**Turtle Creek No. 3 Primary Pump Station Project**  
**Solicitation Number: CO-00404-SM**  
**Job No.: 21-6001**

**ADDENDUM NO. 5**  
**September 22, 2021**

**PUMP STATION FLOOR PLAN**  
1/4" = 1'-0"

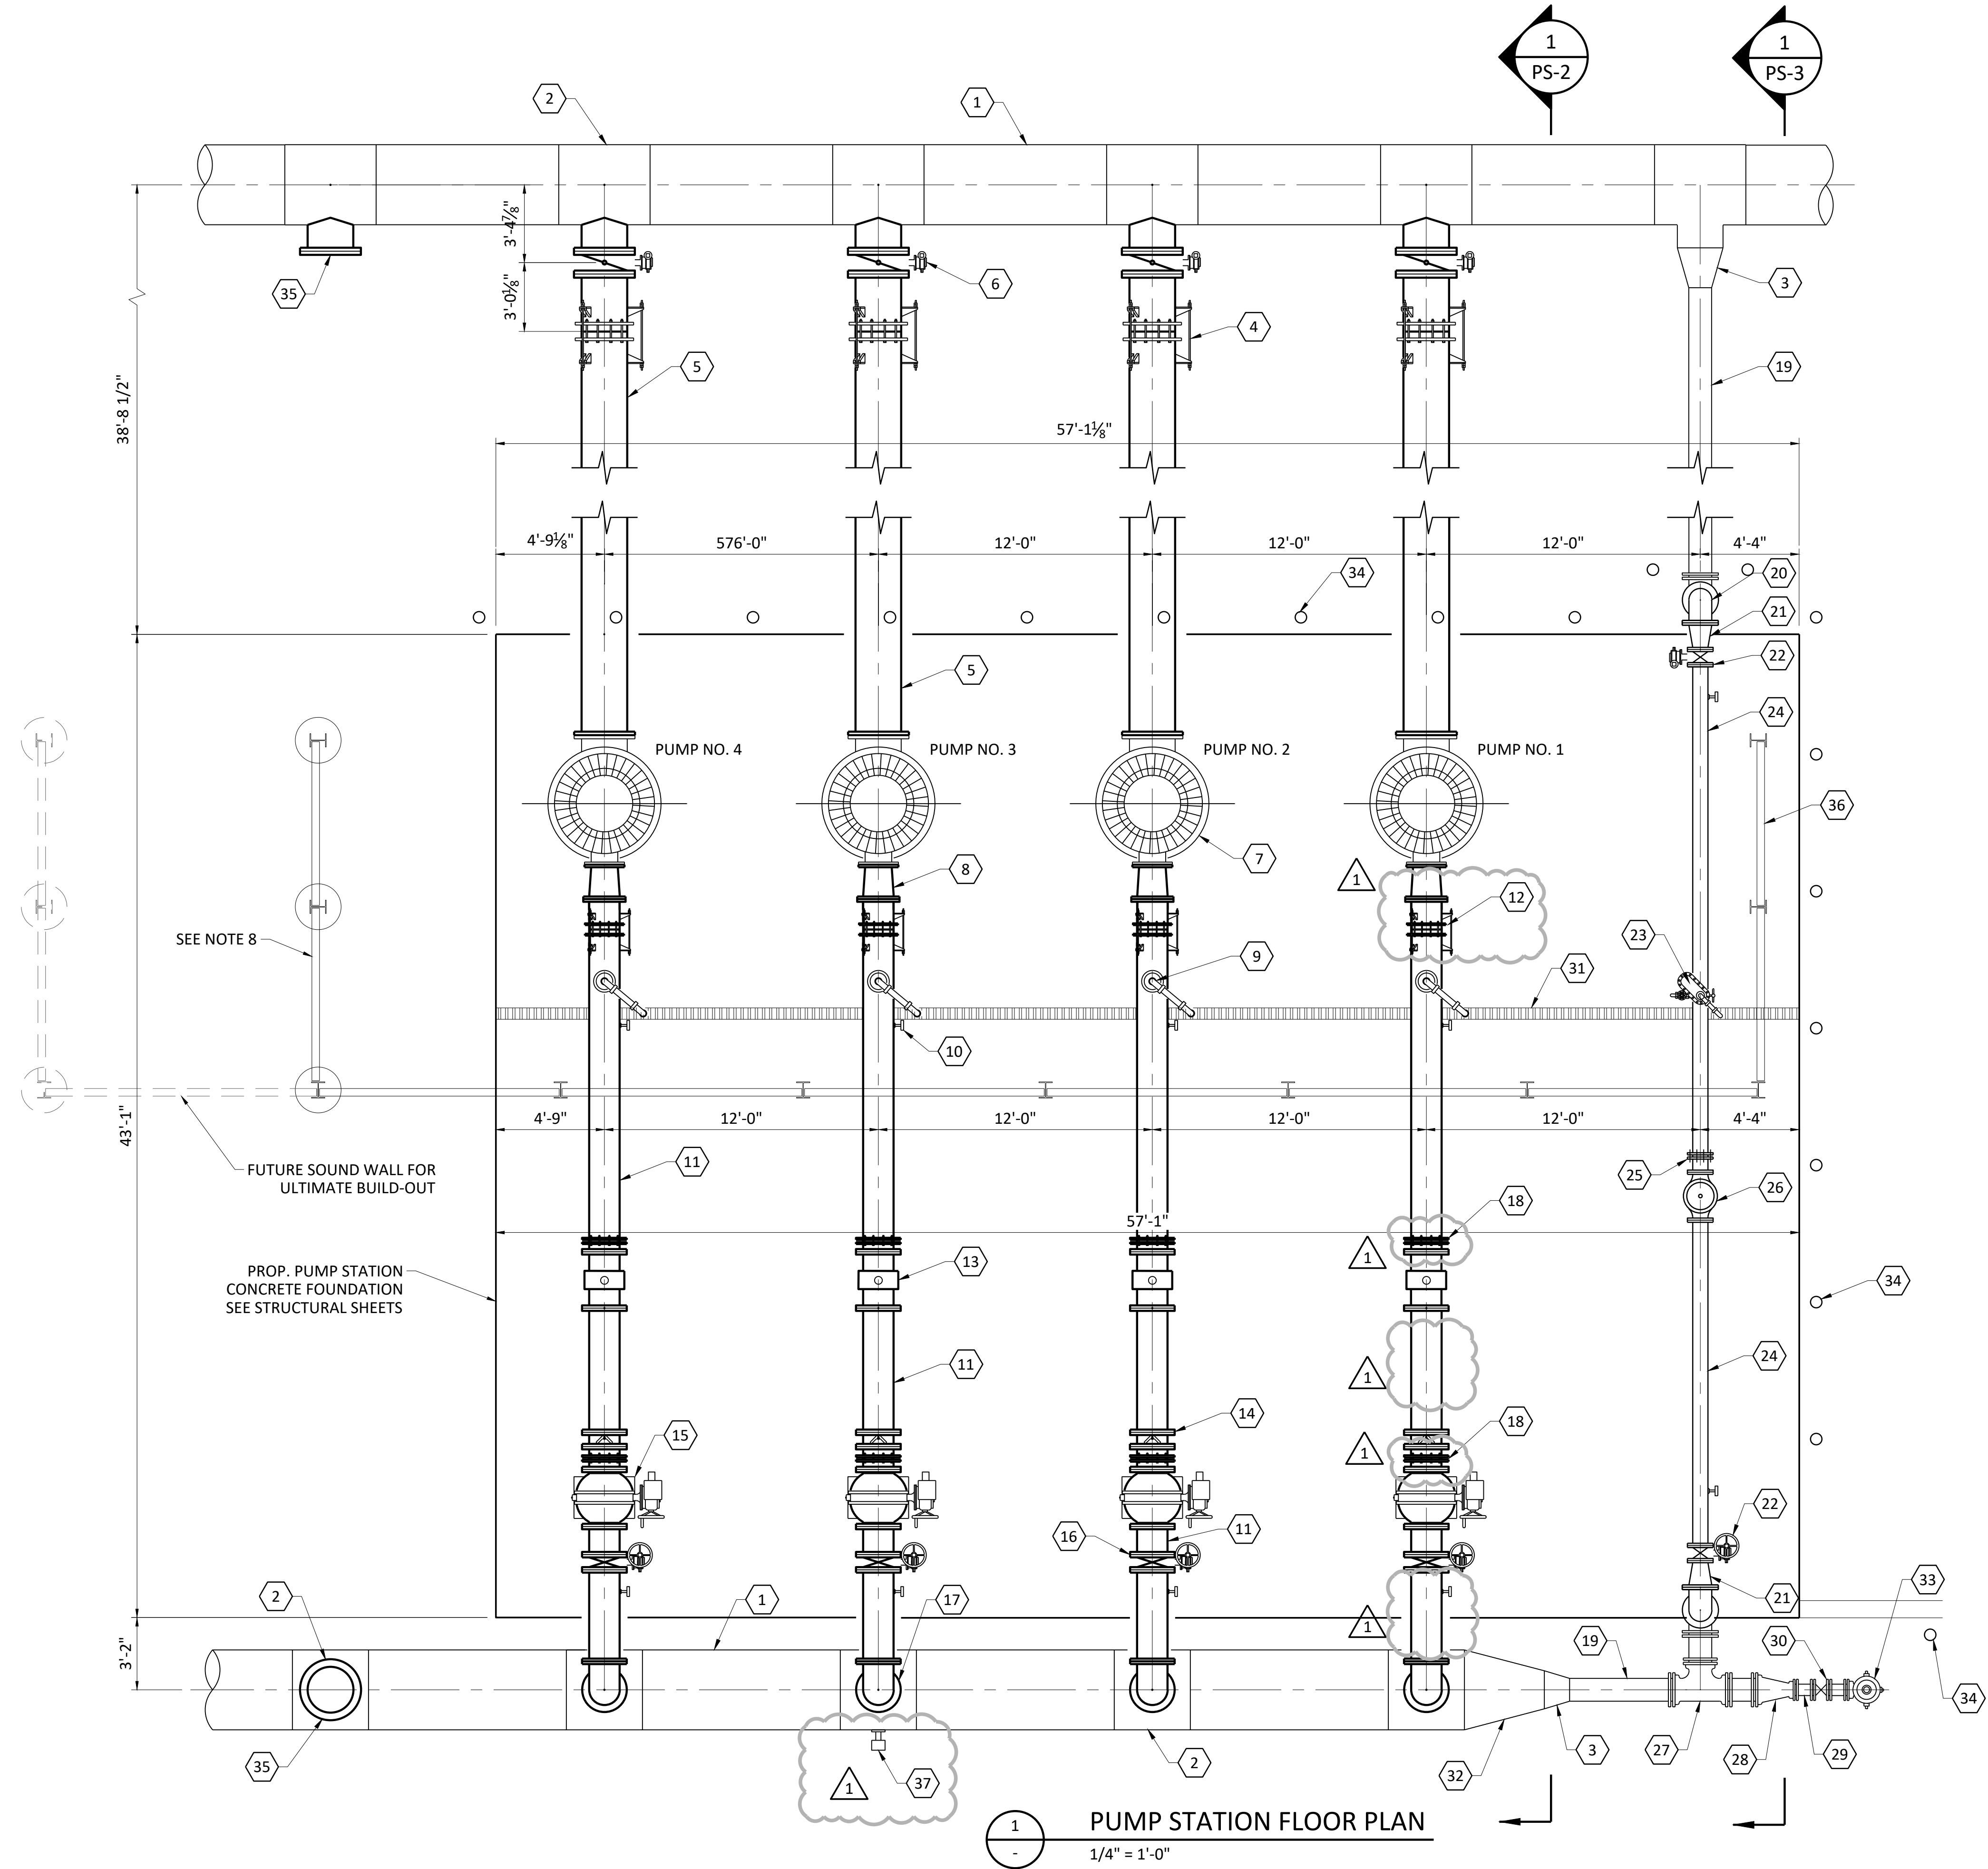
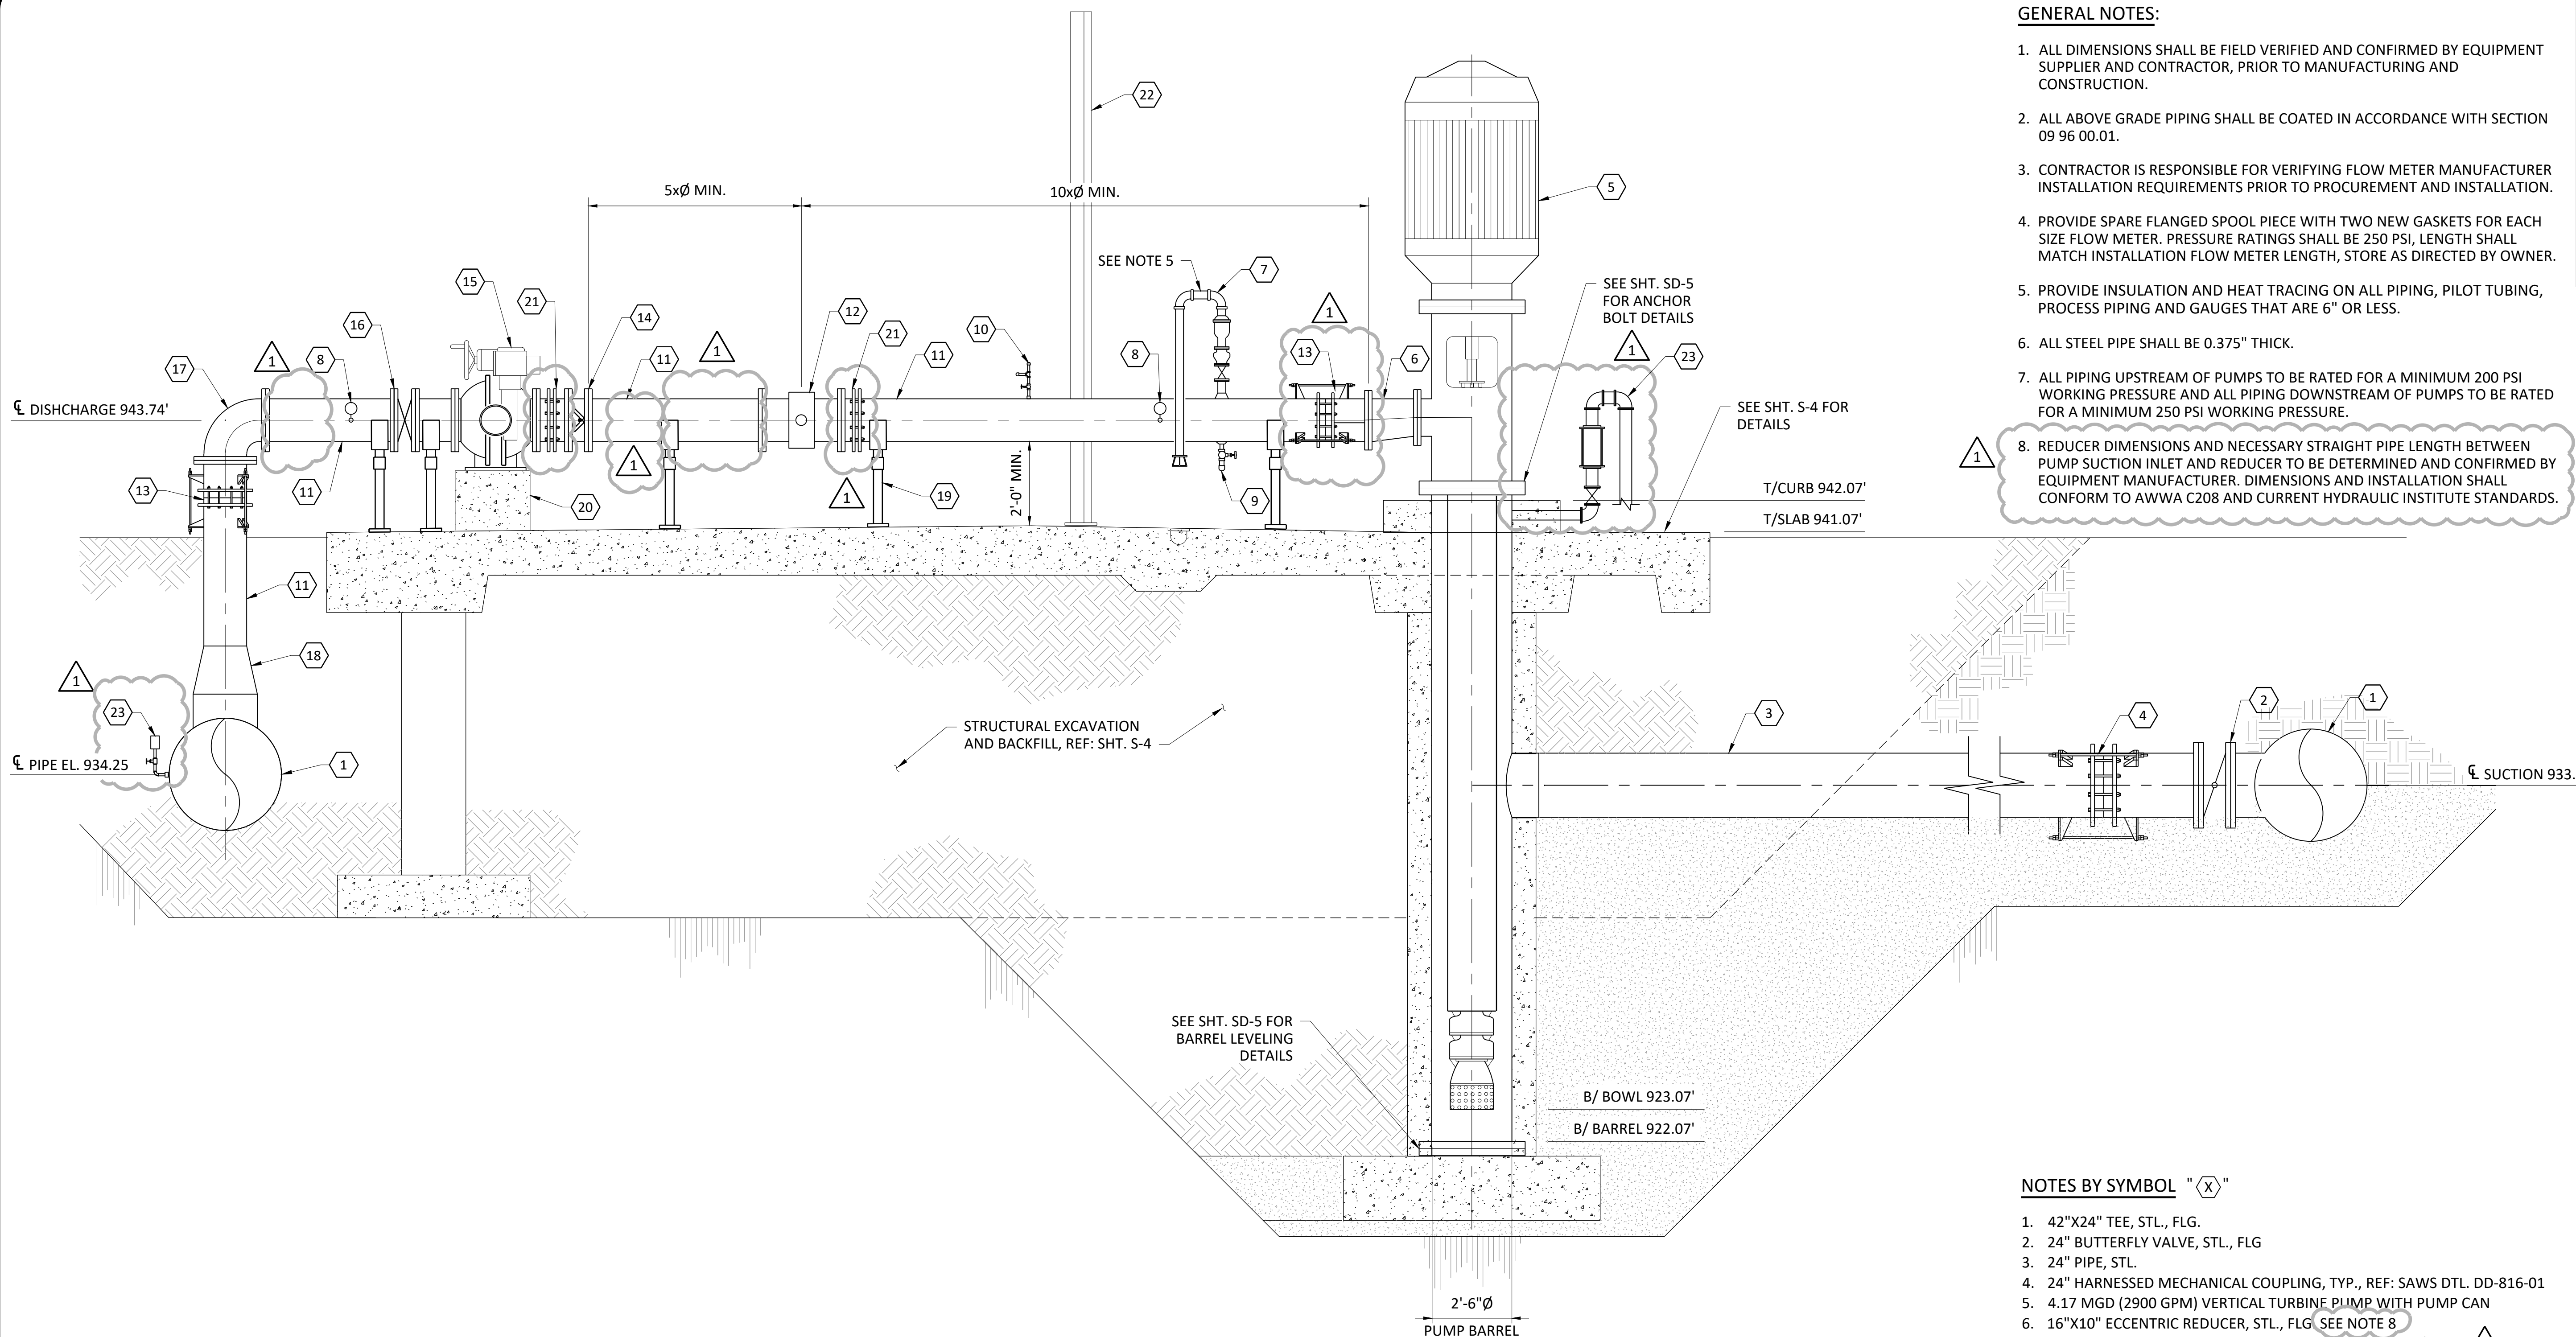
- 27. Question: DWG'S PS1 WORK NOTE 18 AND DWG PS2 WORK NOTE 21 CALL FOR RESTRAINED FLEXIBLE COUPLINGS. THE ONLY FLEXIBLE COUPLING SPECIFIED IS IN SECTION 33 11 13.13.2.02.L AND IS NOT A RESTRAINED COUPLING. FURTHER, THE RESTRAINED COUPLINGS ON DWG'S PS1 & 2 APPEAR TO BE SHOWN AS DEPEND-O-LOK TYPE. WHAT TYPE OF COUPLING IS REQUIRED AT THIS LOCATION?**

*Response: Note by Symbol 18 on Drawing PS-1 and Note by Symbol 21 on Drawing PS-2 have been modified to specify a flanged coupling adapter which must conform to Section 33 11 13.13 Steel Pipe (AWWA C200). Refer to Item No. 4 and 5 in the CHANGES TO THE PLANS section of this addendum.*

5. **Delete** Drawing PS-2 in its entirety **and replace with** revised Drawing PS-2 included in this addendum.
6. **Delete** Drawing CH-4 in its entirety **and replace with** revised Drawing CH-4 included in this addendum.
